Process Sheet

Customer Job Number : CU-DAR001 Dart Helicopters Services

: BEARING CAP

Subject: 1" caps

D3121-25 CAP (SCALE 1:1)

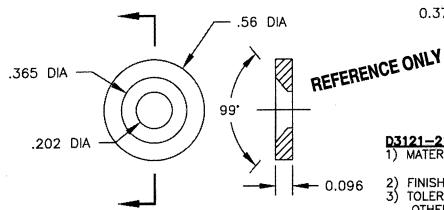
As discussed, please launch a WO immediately to make 400 of these caps D3121-25 at 1.000" OD rather than the 1.024" indicated on the drawing. Serge will give you a marked up print shortly to cover this. We will be changing this part for all future production as well, including items in-stock.

The drwg has not been changed.... If someone could get this changed to 1", I can get someone started on them asap. ${\tt LL}$
